PROJECT NUMBER: SP2020-027
PROJECT NAME: Site Plan for Alliance Addition Phase 2
SITE ADDRESS/LOCATIONS: 6601 HORIZON RD

CASE CAPTION: Discuss and consider a request by Cameron Slown of F. C. Cuny on behalf of the owner N & H Legacy for the approval of a Site Plan for a multi-tenant retail building on a 2.22-acre tract of land identified as Lots 8 & 11, Block 1, Alliance Addition, Phase 2, City of Rockwall, Rockwall County, Texas, zoned Planned Development District 57 (PD-57) for Commercial (C) District land uses, situated at the southeast corner of the intersection of Andrews Drive and Horizon Road [FM-3097], and take any action necessary.

DEPARTMENT	REVIEWER	DATE OF REVIEW	STATUS OF PROJECT
PLANNING	David Gonzales	10/22/2020	Needs Review

10/22/2020: SP2020-027; Site Plan for Alliance Addition Phase 2

Sheet Title:
LANDSCAPING PLAN
LS-101

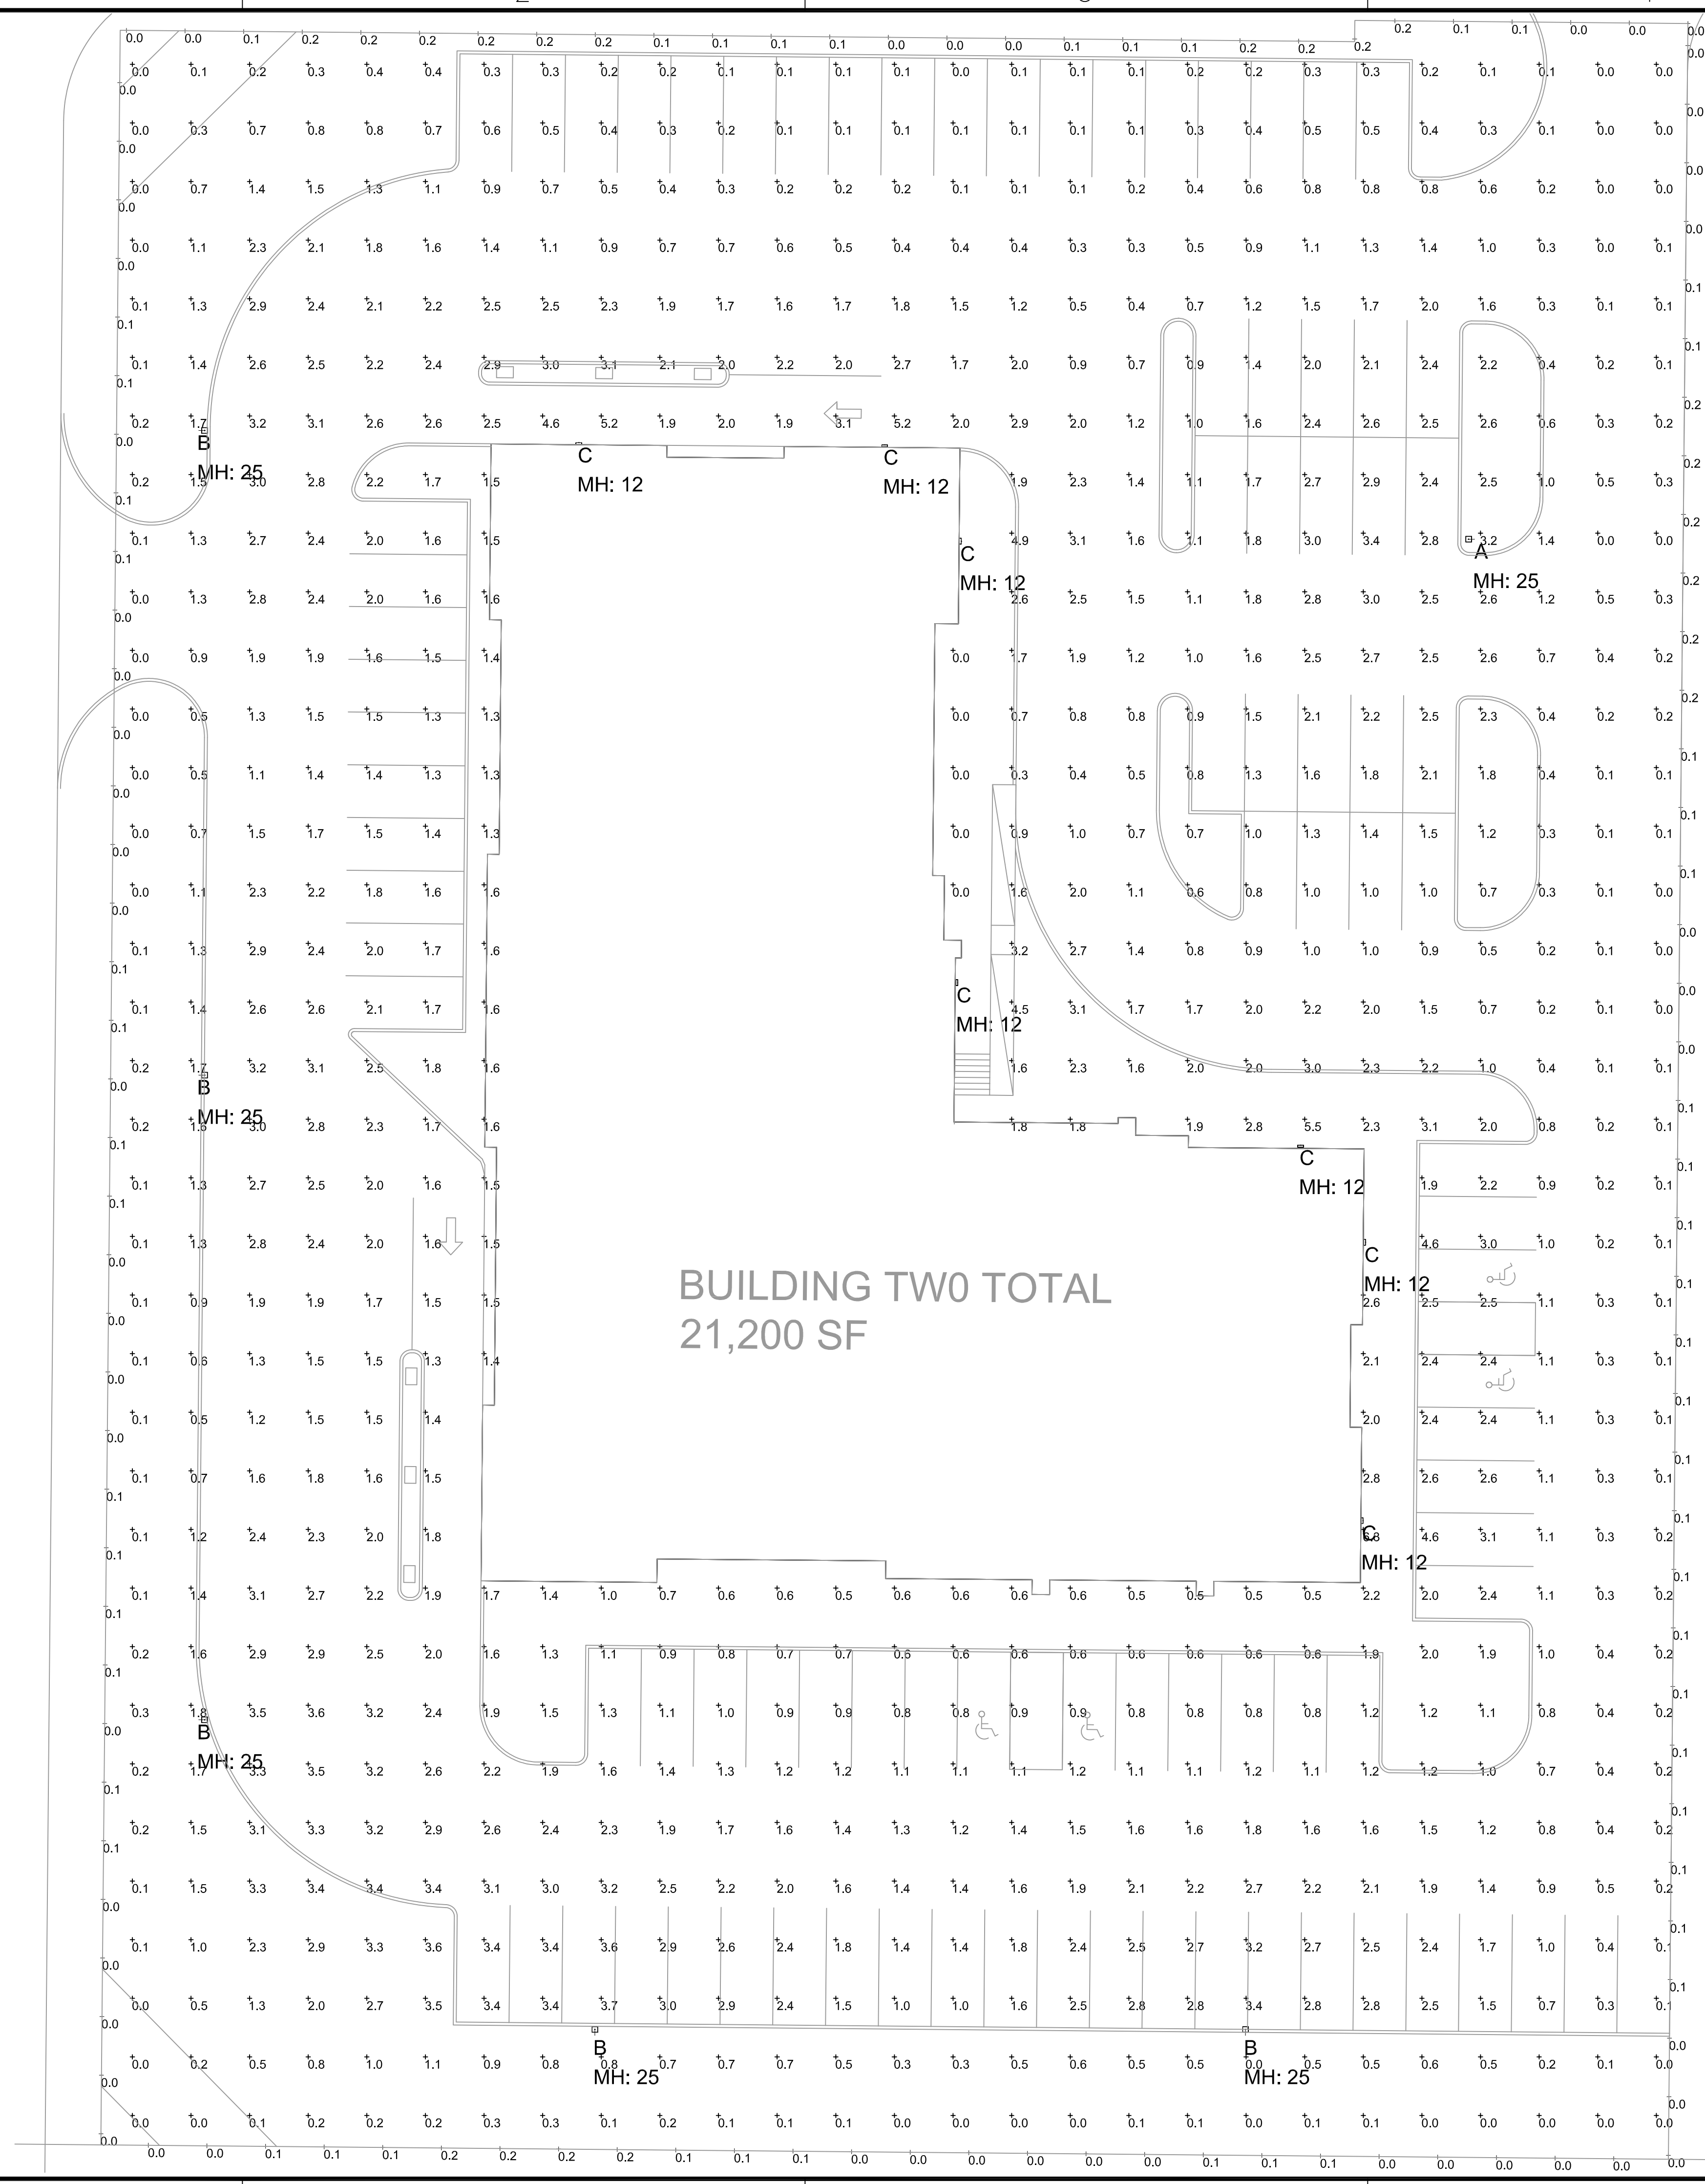
1. Update the Landscape Plan to match the Site Plan. (Subsection 03.04. A. of Article 11)
2. Verify the area of the tract. (Subsection 03.04. B, of Article 11)

3. After acreage is verified the impervious vs. landscaped area may need to be recalculated. (Subsection 01.01. B, of Article 05)
4. Indicate the locations of all existing and proposed landscaping. Arial imagery indicates that there are trees along Horizon Road that are not indicated on this Landscape Plan. (Subsection 05.03. B, of Article 08)

10/20/2020: Canopy tree are minimum 4" caliper per ordinance not 3"
Please identify species on the plan, so I can see the actual design layout

M.6 (8) also needs to be addressed; we need 7 canopy trees along Andrews, there are only 4 indicated currently. **-Please see the attached revised Landscape Plan**

ROCKWALL, TEXAS
Improvements for
ALLIANCE ADDITION NO. 3
SITE PLAN

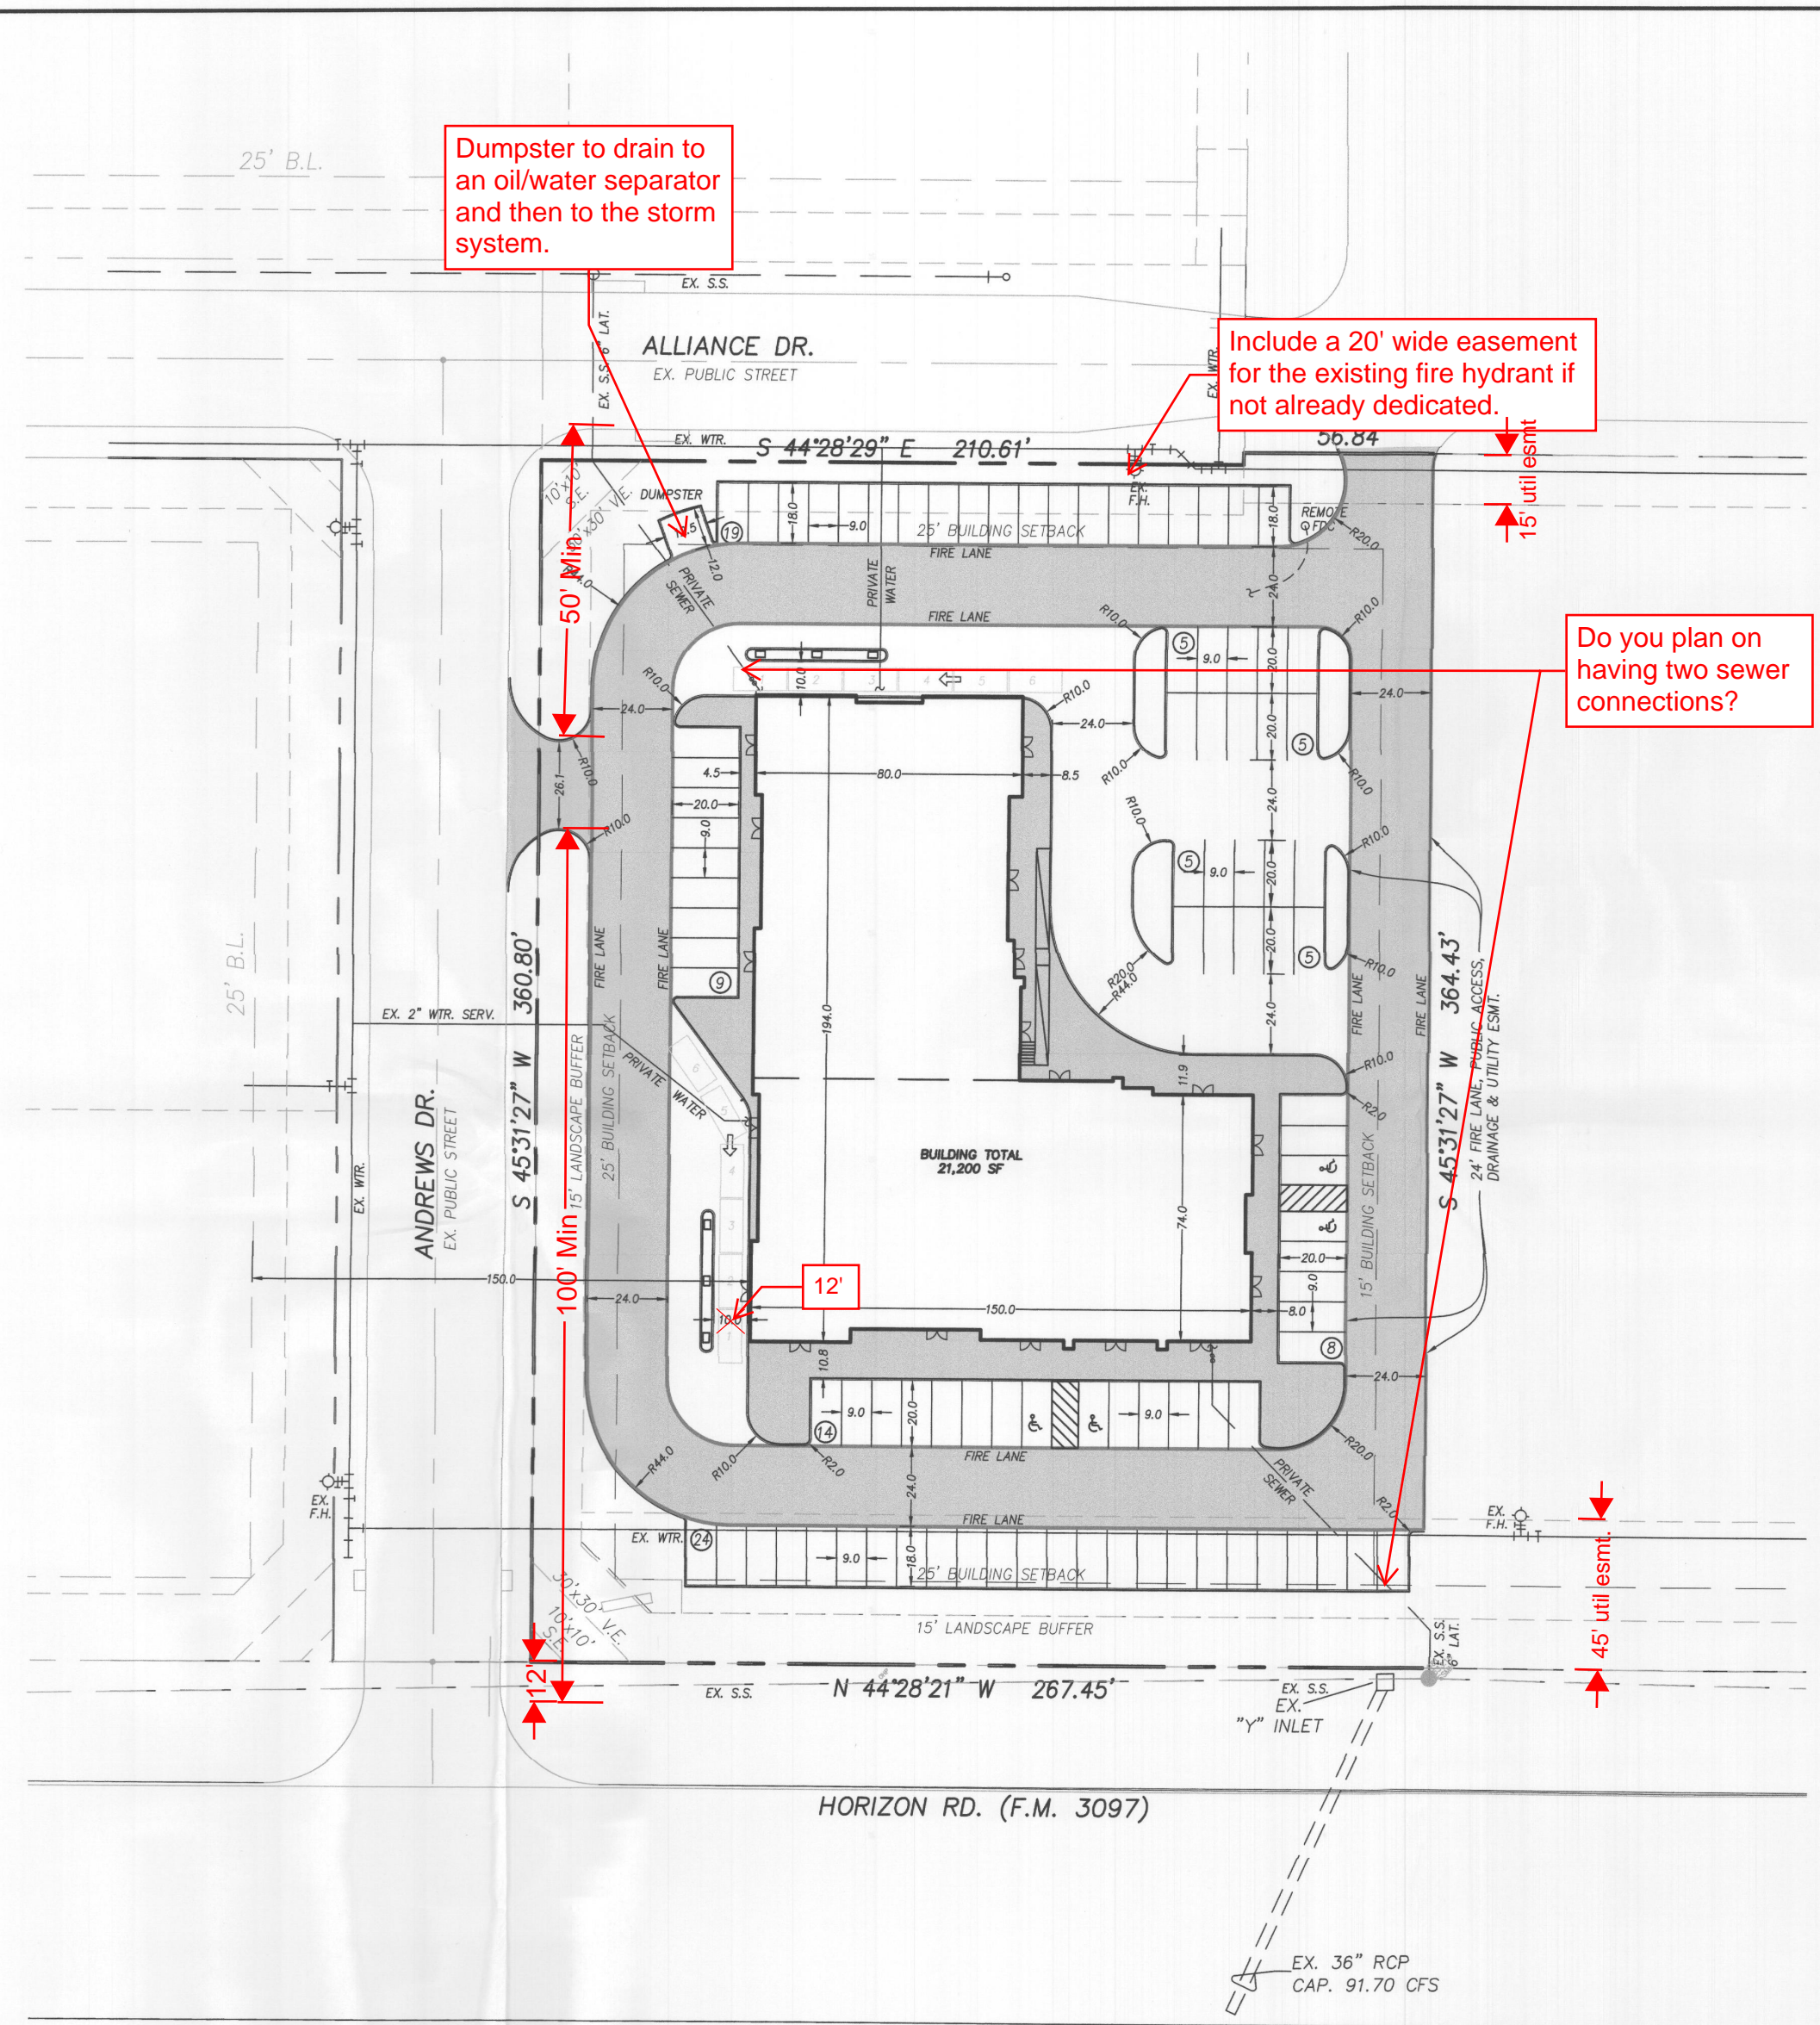
Dumpster to drain to an oil/water separator and then to the storm system.

Include a 20' wide easement for the existing fire hydrant if not already dedicated.

Do you plan on having two sewer connections?
